# Access Compliance Report

## Public Rights-of-Way

### (Curb Ramps)

Intersection ID: 44938	Main Street: NATHAN_DR	Cross Street: ACORN_FOREST_LN	Location: SW
ADA ID: FB40A45F5D12	Ramp Type: PerpDiag	Initial Pass/Fail: Fail	Overall Compliance: No
Severity Score: 22.5			
Codes/Mitigation Info/Possible Solution		Field Measurements/Component Compliance

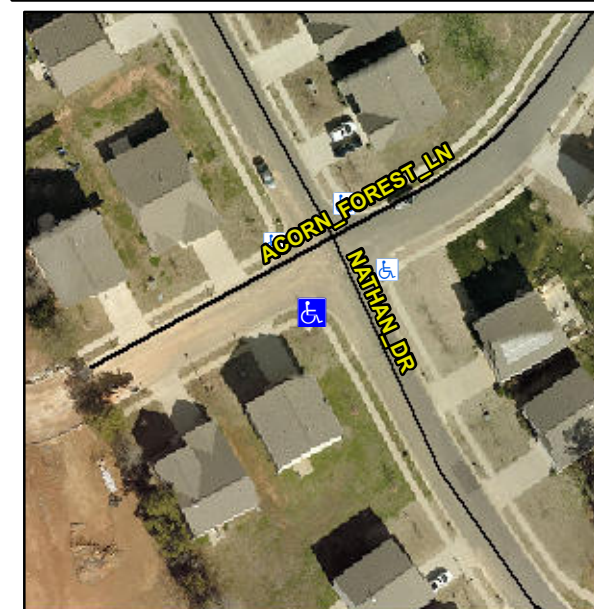
**Remove & Replace Curb Ramp With Two New Directional Ramps or Equivalent.**

**R304.5.1, R304.2.2, R304.5.3**

Compliance	Description	Data	Compliance	Description	Data
N/A	Ramp Length (in)	49.0	No	Ramp Slope (%)	11.1
No	Ramp Width (in)	46.0	No	Ramp XSlope (%)	3.1
N/A	Flare Type LT	N/A	N/A	Flare Type RT	N/A
N/A	Flare Slope LT (%)	N/A	N/A	Flare Slope RT (%)	N/A
N/A	Flare Traversable LT?	N/A	N/A	Flare Traversable RT?	N/A
N/A	Landing Length (in)	N/A	N/A	DWS Provided?	N/A
N/A	Landing Width (in)	N/A	N/A	DWS Contrast?	N/A
N/A	Landing Slope (%)	N/A	N/A	DWS Length (in)	N/A
N/A	Landing X Slope (%)	N/A	N/A	DWS Full Width?	N/A
N/A	Landing Curb? (Y/N)	N/A	N/A	DWS Offset (in)	N/A
N/A	Shared Landing?	N/A			
N/A	Gutter Ponding?	N/A	N/A	Gutter Slope (%)	N/A
N/A	Gutter Lip Ht (in)	N/A	N/A	Gutter X Slope (%)	N/A
N/A	Painted X Walk1?	No	N/A	Painted X Walk2?	No
	X Walk 1 Direction	To E		X Walk 2 Direction	To N
N/A	X Walk 1 Width (in)	N/A	N/A	X Walk 2 Width (in)	N/A
	X Walk 1 Slope (%)	2.4		X Walk 2 Slope (%)	0.7
	X Walk 1 X Slope (%)	1.5		X Walk 2 X Slope (%)	2.9
